The new Downee gudgeon replaces the old forged version and incorporates a bush that will reduce metal on metal wear. A nail hole has been added for extra stability, as well as fully threaded rod. All bolt through gudgeons are now fully adjustable. These gudgeon will be rolled out over the coming months and will be available to purchase by using existing Downee codes at the same great price.

CHANGEOVER TO NEW DOWNEE® GUDGEON

WOODSCREW GUDGEON - GALVANISED

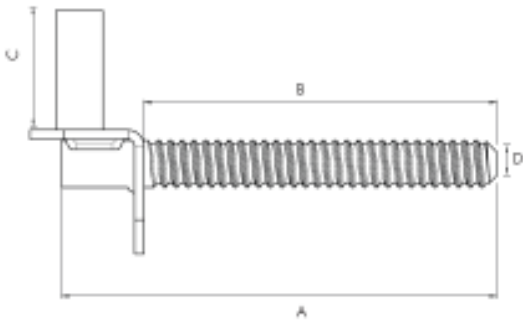
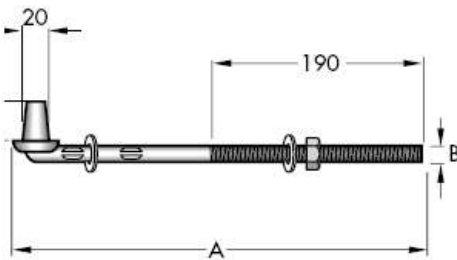
Code	Pipe	A	B	C	D	Bush	Ctn
G1	20nb	155	120	50	20Ø	X	20
G3	25nb	155	120	50	16Ø	✓	20
G4	32nb	155	120	50	20Ø	✓	20

*G2 will be phased out once stock is exhausted.

BOLT THROUGH GUDGEONS – GALVANISED – Now Adjustable Gudgeon

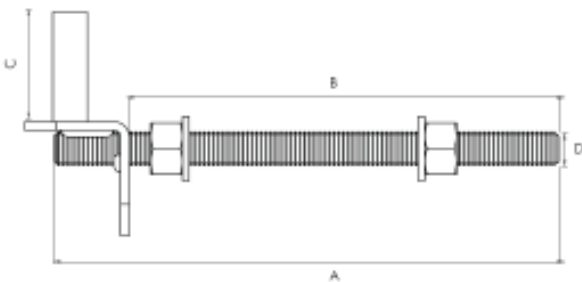
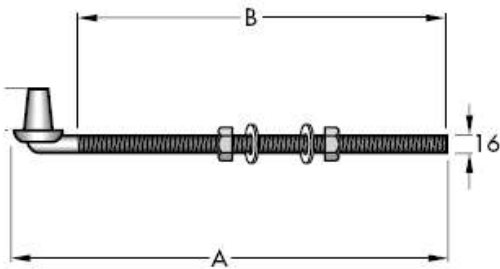
Code	Pipe	A	B	C	D	Bush	Ctn
G7	25nb	400	365	50	16Ø	✓	15
G8	25nb	500	465	50	16Ø	✓	15
G11	32nb	500	465	50	20Ø	✓	10

*G7S will be phased out once stock is exhausted.

BOLT THROUGH HINGE STRAP GUDGEONS - GALVANISED

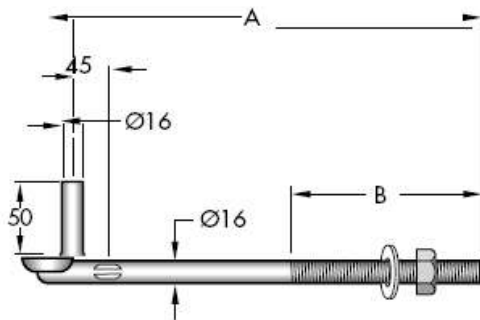
Code	A	B	C	D	Bush	Ctn
G514	400	365	50	16Ø	X	20
G516	500	465	50	16Ø	X	20

G506, G508, G510 will be phased out once stock is exhausted.
